SSD-70283710: 1 Crescent Street, Holroyd

Transport Impact Assessment - Response to Submissions

14 November 2025

The Transport Planning Partnership

Figure 3.1: Driveway Locations

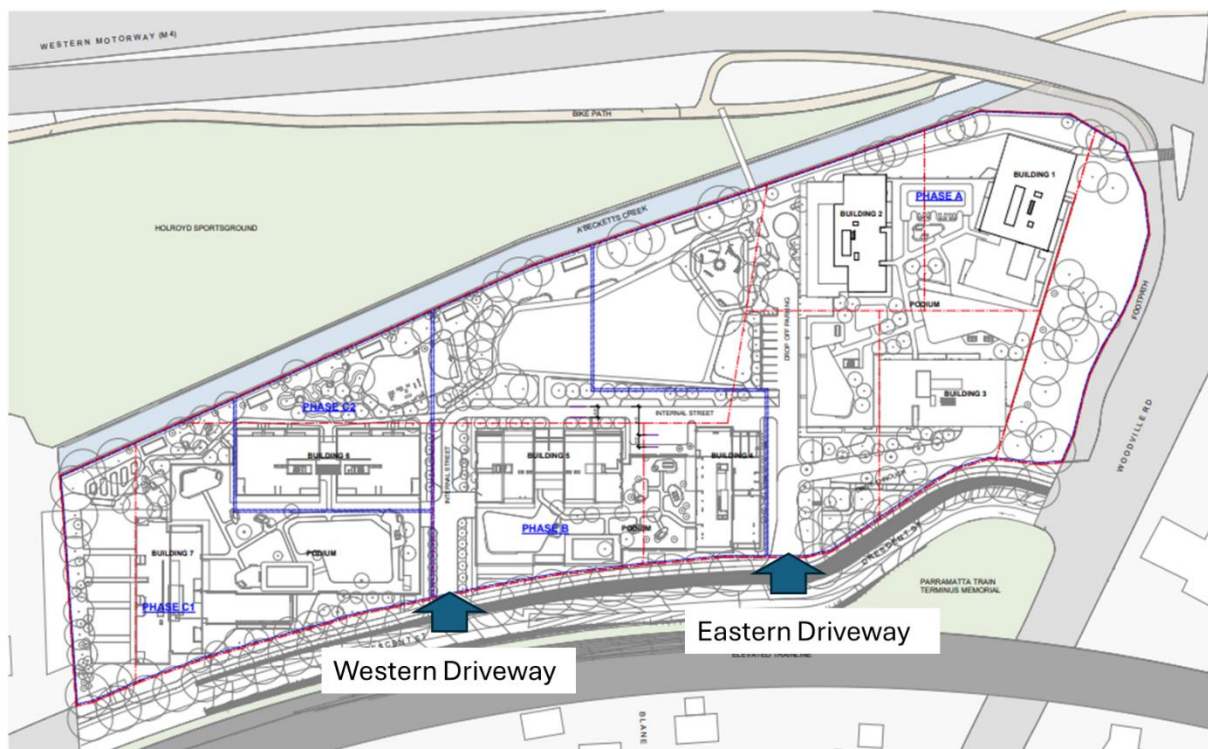
TfNSW 2-1	Proposed Driveways in Crescent Street - TfNSW note that there are two driveways proposed in Crescent Street for vehicular access (i.e. western and driveway driveways). TfNSW raises road safety and traffic flow concerns with the proposed eastern driveway in Crescent Street, which is located on a bend near Woodville Road and permits all turning movements into and out of the site. TfNSW is concerned with potential queuing of the right turn bay extending out of the bay and potentially impacting on the operation of the right turn into Crescent Street from Woodville Road, which has been recently constructed by TfNSW. - TfNSW raises road safety concerns relating to the turning movements at the eastern driveway. Vehicles turning right into the driveway from Crescent Street are required to turn across 3 opposing traffic lanes	- Access to the site has been provided in this location on all plans since 2015 including for the approved rezoning. - It was the location which served the entire previous development for the car parking and servicing function and was not known to cause issues. - Traffic modelling has shown that the queueing suggested by TfNSW beyond the driveway will not generally occur after the upgrade of the Woodville Road / Crescent Street intersection.	Section 3

CC-8-C	The driveway's proposed location and the limited capacity of a proposed right turn treatment from Crescent Street into the driveway may create a queue spill back onto Woodville Road.	This is the location of the existing driveway. It is some 100m west from the Woodville Road intersection.	Section 3
CC-8-D	The queue on Crescent Street from the Woodville Road signalised intersection is likely to queue past the proposed driveway and therefore the opportunities to turn into the eastern driveway will be limited.	Right turn bay will be provided. Modelling indicates that it has enough capacity to store right-turning queues. Aimsun modelling was undertaken for the peak two hours of the morning (7:00am – 9:00am) and evening (4:00pm – 6:00pm) weekday periods. While the Sidra Intersection covers the peak morning (7:00am – 8:00am) and afternoon (5:00pm – 6:00pm) peak traffic hours.	Section 3
CC-8-E	Driveway dimensions allow for one lane in and one lane out which will be insufficient to satisfy traffic generation.	With the intersection upgrade, the modelling indicates that this is not the case.	Section 3

The driveway locations have not been modified by the amended proposal as the vehicle access arrangements proposed as part of the SSDA reduced the need for internal vehicle trips and allows the development to function as a staged construction development.

Figure 3.3: Sidra Driveway intersection design

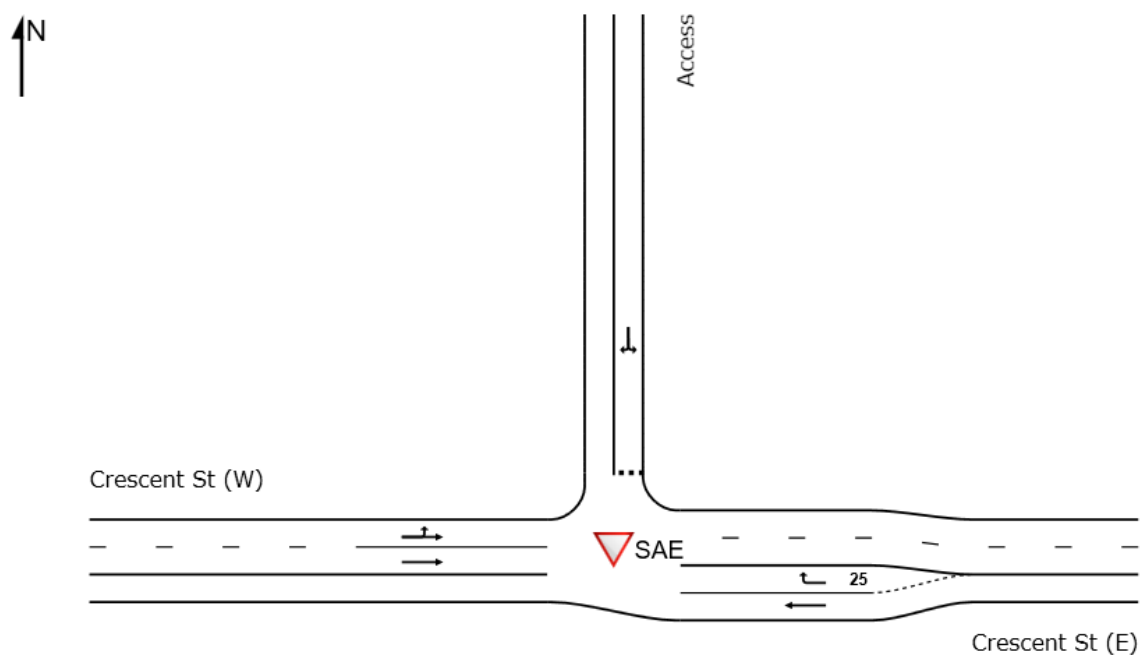
Issue	Traffic Transport and Accessibility	Applicant Response	Addressed in
	uncontrolled from a short right turn bay and vehicles turning right out the site are required to turn across 5 opposing lanes. "		
TfNSW-2-2	Amendment: TfNSW recommends that the access arrangement be amended, as part of the Response to Submissions (RtS) as follows: • Restrict traffic movements at the eastern driveway in Crescent Street by providing a self-enforcing, left in/left out arrangement with all right turn movements into the development from Crescent Street being permitted only from the western driveway. • Adjustments to the internal street arrangement so that all traffic turning right into the site can access the car parking spaces from the western driveway. This may require an extension of the right turn bay proposed at the western driveway to accommodate the volume of right turning traffic generated by the development	This proposed arrangement would have significant impacts on the functionality and staging. Further, it would divert more traffic including heavy vehicles past residential areas of the development and require significant widening of internal roadways to allow two-way traffic flow. Again, modelling has shown that right turns into the eastern driveway will be acceptable and not queue back beyond the proposed turn bay.	Section 3

The access driveways have been modelled as a network. The eastern driveway was modelled with two through lanes on the Crescent, as shown in Table 1.1. The third lane will become parking

Figure 3.7: M4 Alternative Access Route

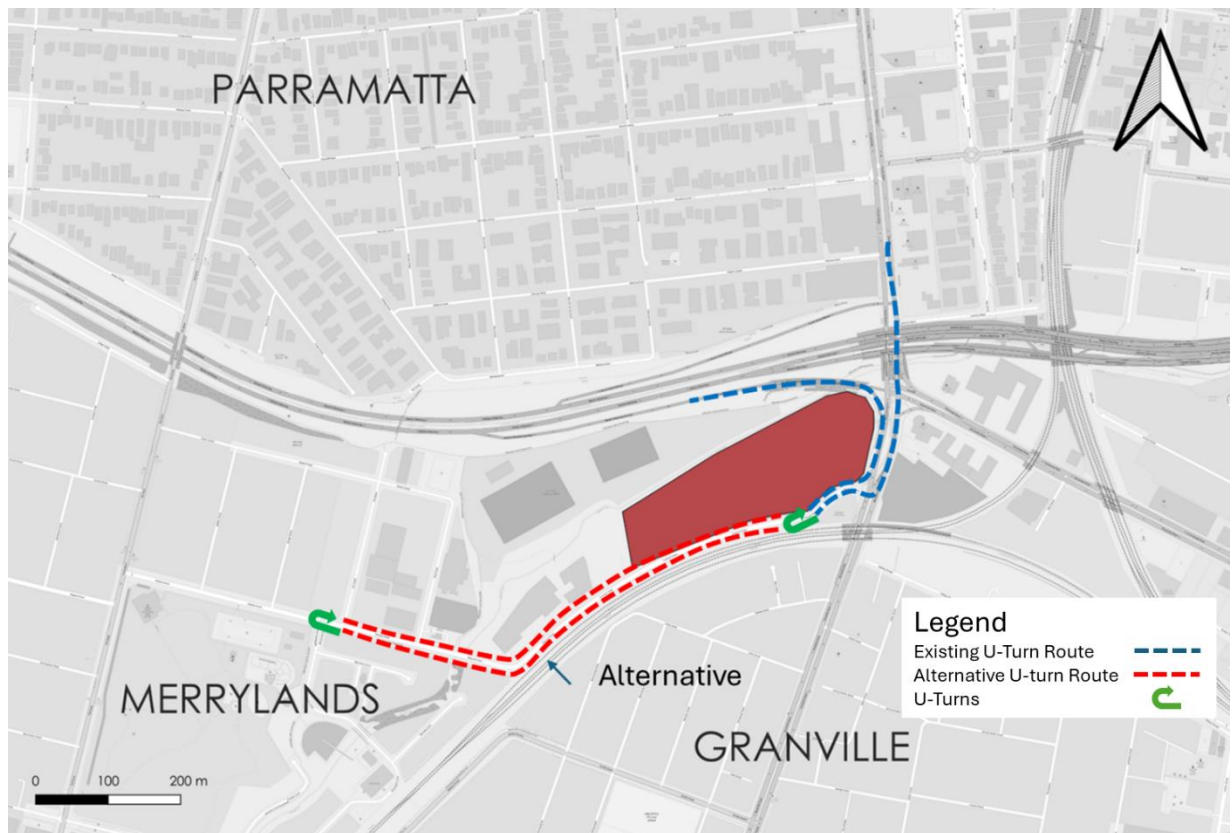
PARRA-3	Site Access At the SEARs stage, Council raised concerns regarding motorists travelling southbound in Church Street, using the existing driveway in Crescent Street to perform a U-turn to access the M4 in the westbound direction. This behaviour is likely to continue, however, with the proposed development in place, there may be increased conflict with pedestrians on the footpath and vehicles exiting the driveway. The proposal now includes widening of Crescent Street to have 2-3 eastbound lanes past the development's driveway and a dedicated right turn lane into the site. This will likely result in the continued use of this section of road for motorists to perform a U-turn. Further to this, it is apparent that the queuing in Crescent Street in the AM peak will extend beyond the eastern driveway post development. As such, there will be instances where motorists are turning right out of or into the	The driveway is currently unused and is therefore attractive to drivers performing U turns. Once the driveway is reopened for the new development, then drivers would be discouraged from using the driveway as a U-turn facility and are therefore more likely to use the roundabout in Walpole Street or find other routes. It is recommended to install "No U Turn" signs at the driveway and back up with police enforcement.	Section 3

Since the site has been disused, the driveway for the site has been used by vehicles from the north that are trying to enter the M4 Motorway travelling westbound. They do this because the right turn from Church Street to the M4 Motorway has been banned and this is an attractive route. This movement is shown in Figure 3.7.

It is estimated that once the site becomes operational, the driveway will no longer become attractive and drivers will find other ways to turn around, including using the roundabout in Walpole Street or finding other ramps to enter the M4 Motorway.

To further address this issue, it is recommended to provide no U-Turn sign at the driveways and may require enforcement to prevent drivers from performing a U-Turn at this location.

Figure 6.1: End of Trip Facilities

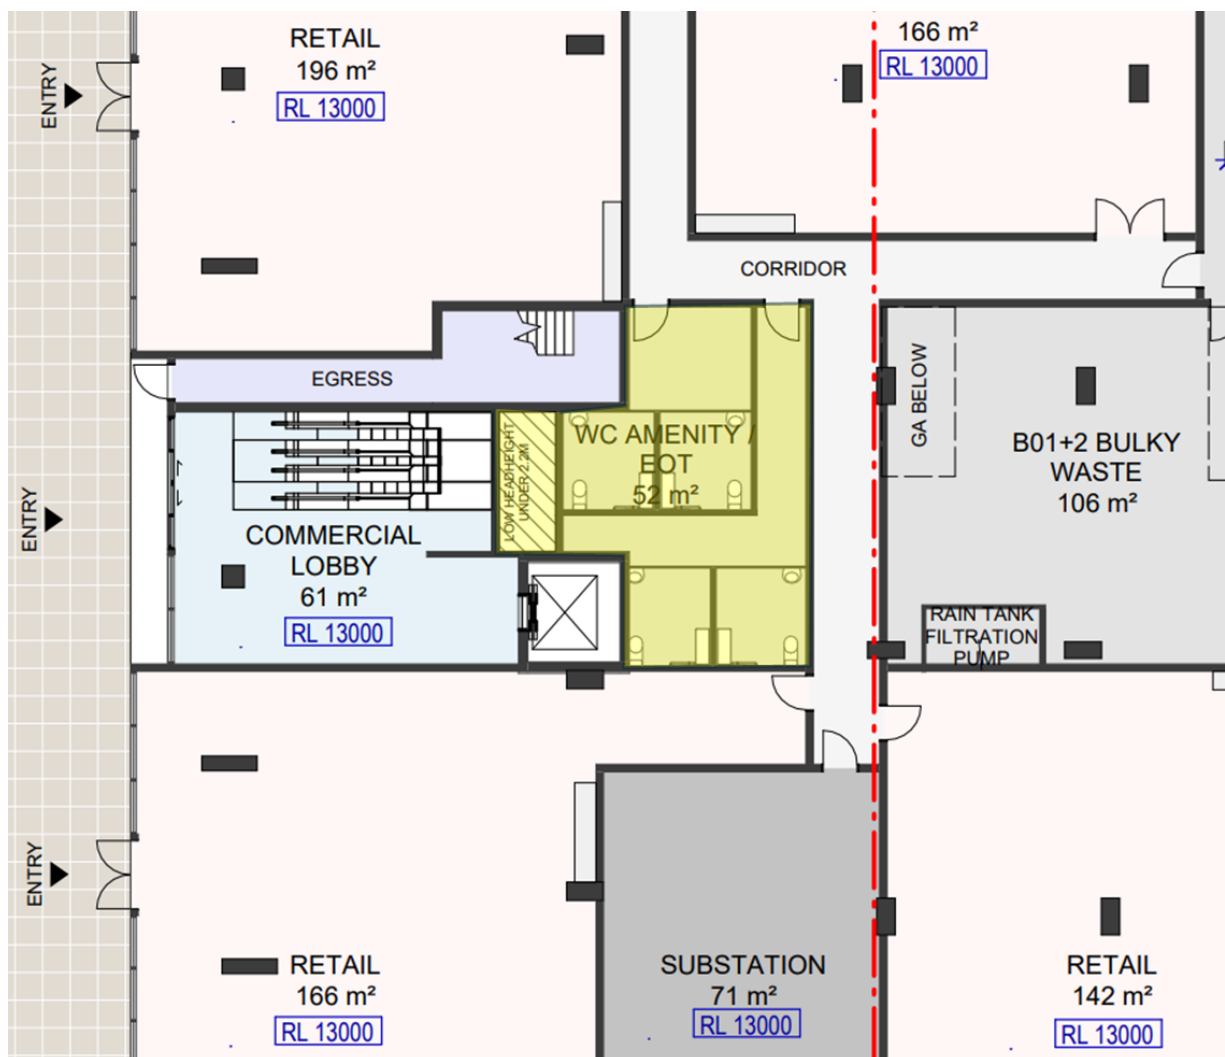
Issue	Traffic Transport and Accessibility	Applicant Response	Addressed in
		- Provide residents with Transport Access Guide. - Review and update the Green Travel Plan - Walking and cycling connections to the surrounding active transport network.	
WH-1-2	Lack of Proper Bus Stops on Woodville Road: Woodville Road lacks adequate bus stops with proper facilities for commuters. This makes public transport less accessible and discourages its use as a viable alternative to private vehicles. Improvements in this area are critical to support any new development in the region."	The proposal is proposing shuttle buses from the site to local destinations to directly assist with promoting transport use other than cars. The site has also been assessed to be within 800m walking distance to Harris Park Station. Further, the site also has a connection to the regional cycling network through a proposed pedestrian cyclist bridge over A'Becketts Creek.	Section 4

The proponent acknowledges the importance of 'end of trip' facilities in supporting active and sustainable transport options. For the non-supermarket retail uses it is proposed to provide end of trip facilities which will be provided in phase 1. The facilities would include:

The location of the facilities on the lower ground level is shown in Figure 6.1.

TITLE
SWEEP PATH ANALYSIS - GROUND FLOOR
12.5M HEAVY RIGID VEHICLE (HRV)

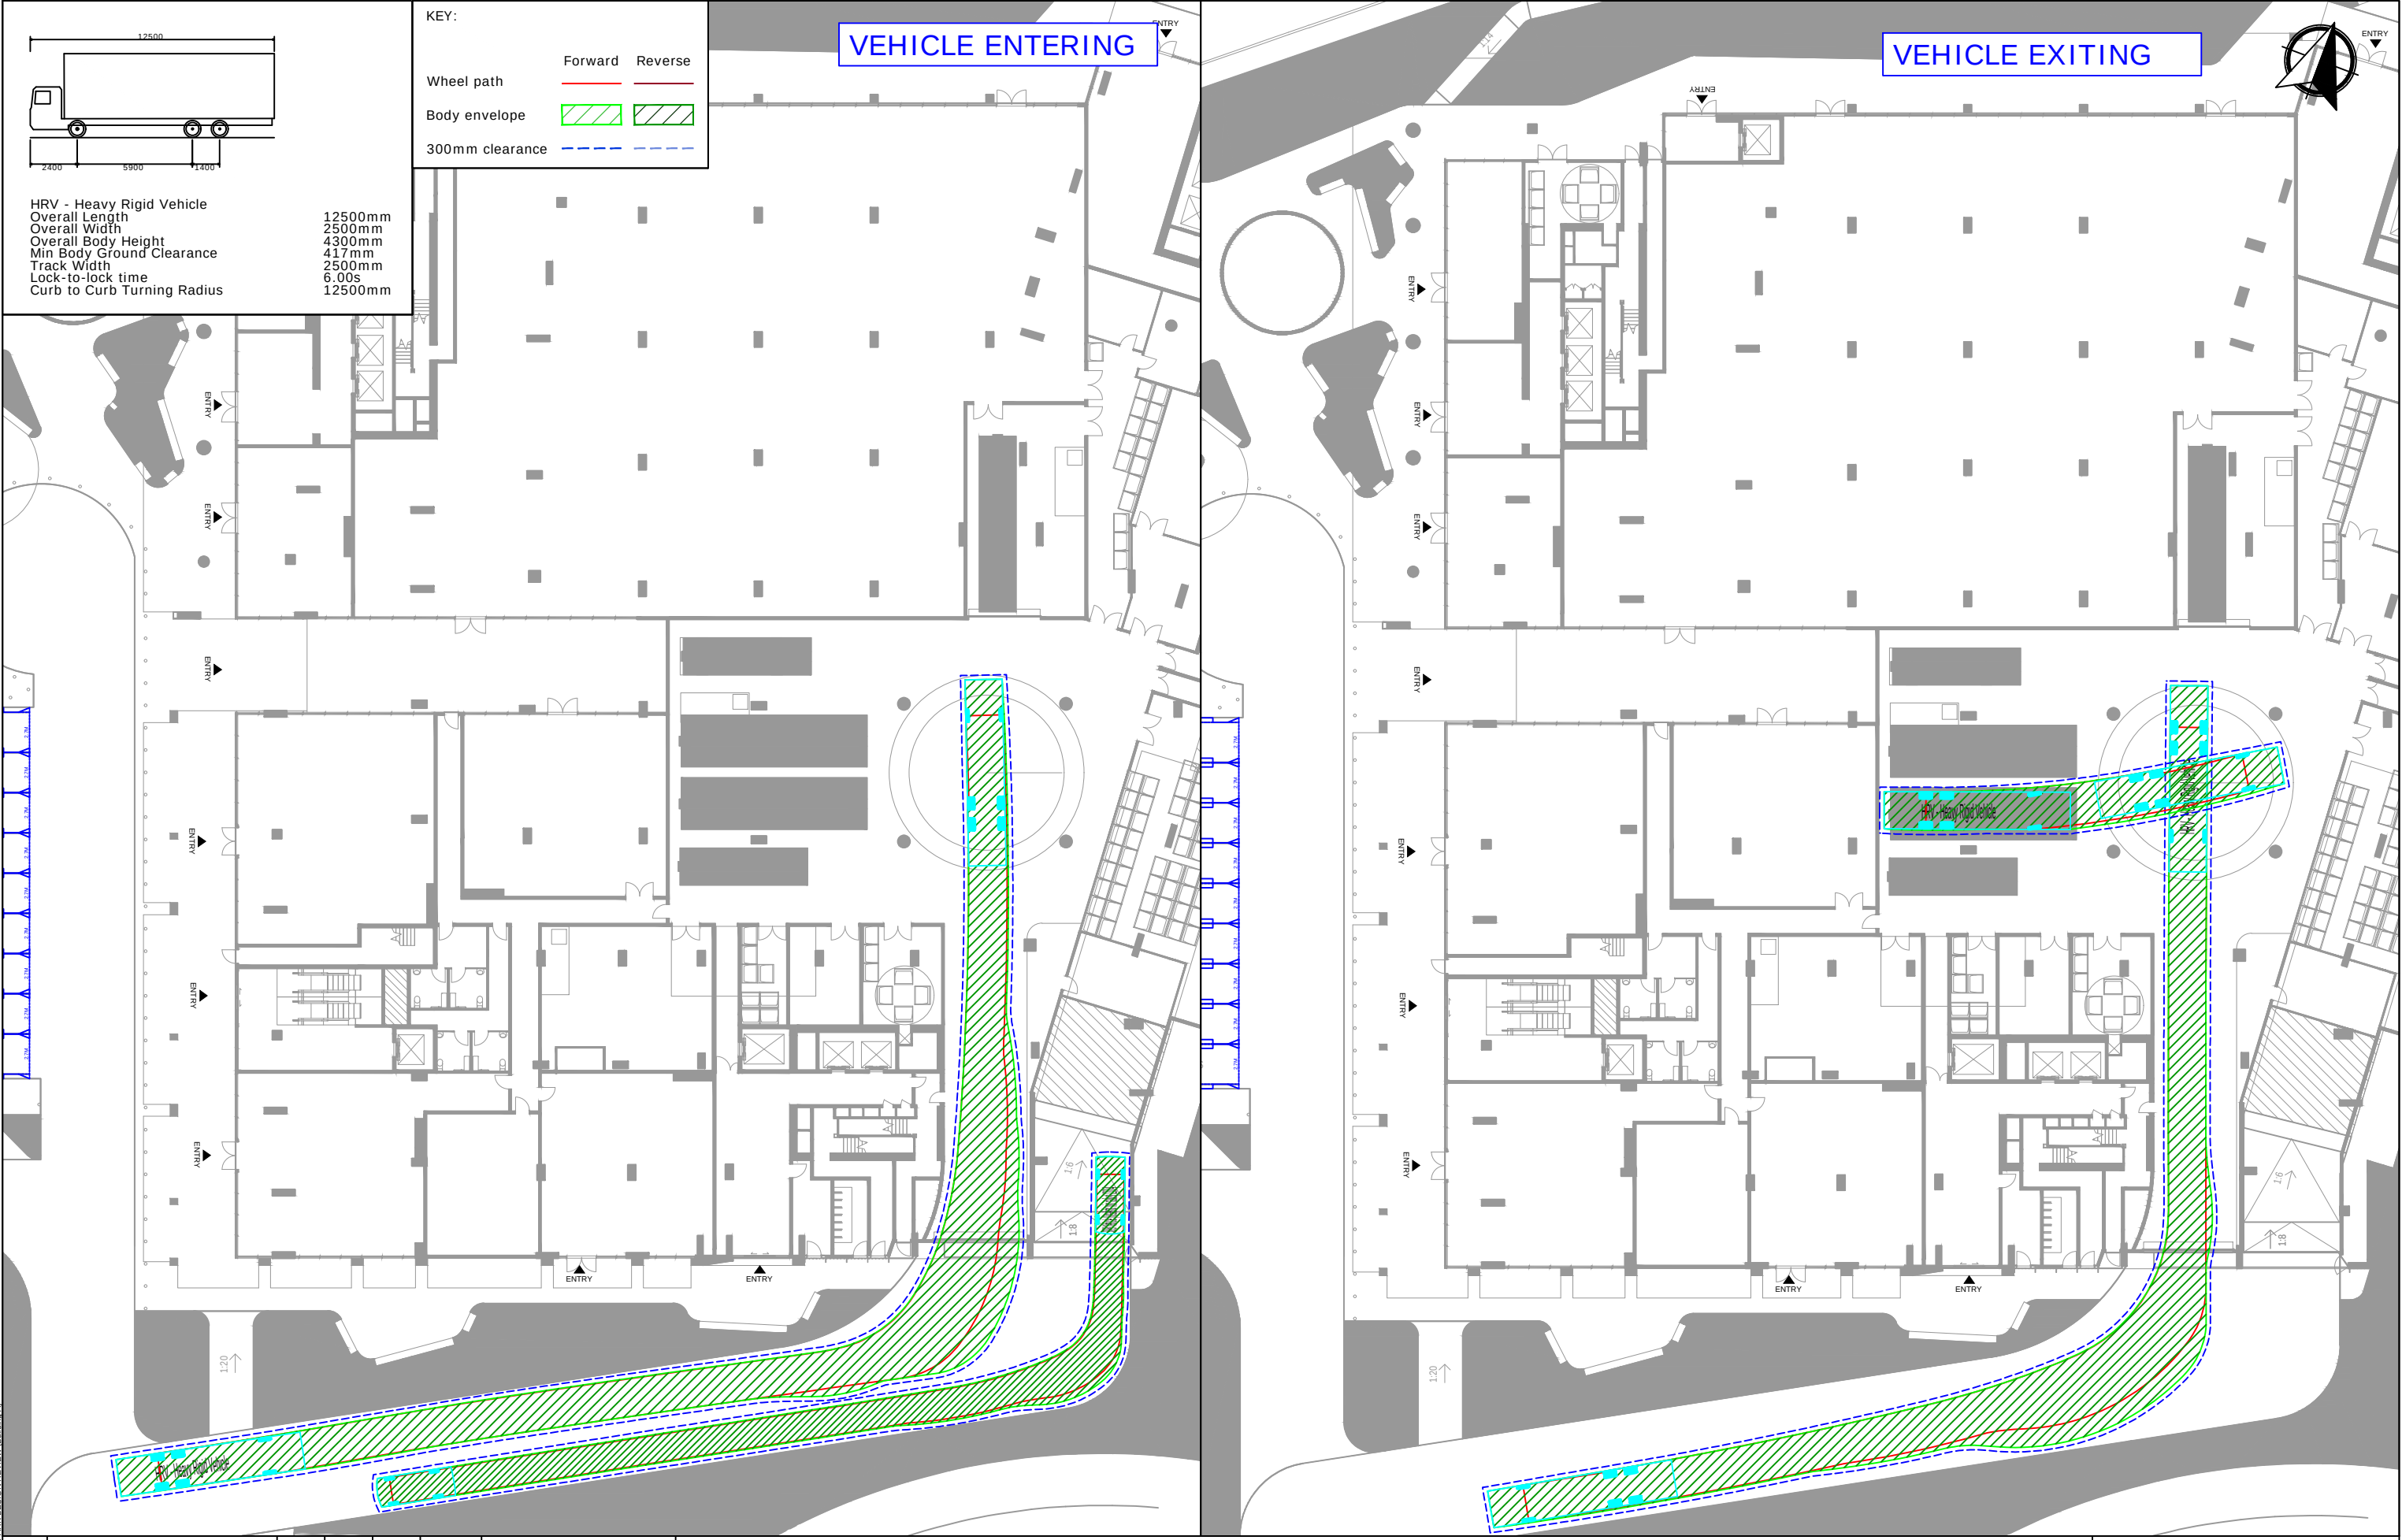
CC-9	Loading bays The 'general loading dock' appears to be deficient in area and detail to accommodate parking, loading and manoeuvring requirements for trucks required for the 2,500m ² of retail space and 5,000m ² of non-retail commercial space. If the general area is utilised by a number of trucks and a further truck then arrives in a forward direction, there appears to be deficient space for that truck to either turn and exit or enter a waiting phase while other truck/s manoeuvre out of the area (if at all possible). Creating a logjam of delivery vehicles and possibly	Loading bay has been redesigned and includes a turntable to manage movement of vehicles.	Section 5.4

DPHI-B-12	Provide further consideration to the space, access and manoeuvrability within the Building 1/2/3 loading dock, in particular:	Loading dock has been redesigned to include a vehicle turntable to allow access for trucks.	Section 5
DPHI-B-12-A	a) it is not possible for HRVs to exit from the (N/S oriented) 'front loading supermarket' and 'rear loading residential' spaces when the (E/W oriented) 'rear loading residential' HRV space is occupied	Loading dock has been redesigned to include a vehicle turntable to allow access for trucks.	Section 5
DPHI-B-12-B	b) swept path analysis of a vehicle entering/exiting the (E/W oriented) 'rear loading residential' HRV space has not been provided	Loading dock has been redesigned to include a vehicle turntable to allow access for trucks.	Section 5

Issue	Traffic Transport and Accessibility	Applicant Response	Addressed in
DPHI-B-12-C	c) the width of the vehicle entrance to the loading dock would only allow one vehicle to enter/exit the dock at the one time. In addition, it is not clear whether vehicles could enter/exit via the entrance if the loading dock spaces were occupied.	It is recommended that loading dock management plan is put in place to manage truck movements into and out of the loading dock.	Section 5
DPHI-B-16-C	c) consider the potential operational noise impact of the operation of the loading dock on future residential occupants within apartments, particularly within podium level and at Buildings 3 and 4	Refer to the E-Labs acoustic response. Additional noise modelling has been undertaken.	Section 5
DPHI-B-12-E	e) provide any necessary additional mitigation measures, or loading dock time restrictions to address potential noise impacts identified in the preceding queries.	It is recommended that loading dock management plan is put in place to manage truck movements into and out of the loading dock.	Section 5

The site will provide three 12.5m long Heavy Rigid Vehicle spaces, and two 8.8m long Medium Rigid Vehicle spaces in the loading dock.

Swept path analysis of the critical areas within the proposed car park and loading areas has been conducted using design vehicles including the Australian Standard 4.91m long B85 vehicle, 5.2m long B99 vehicle, and 12.5m long heavy rigid vehicle. The analysis found that the design vehicles will be able to circulate around the car park and access the service areas satisfactorily. The architectural car park layout plans are provided in **Appendix A** with swept paths and car park assessment are provided in **Appendix B**.
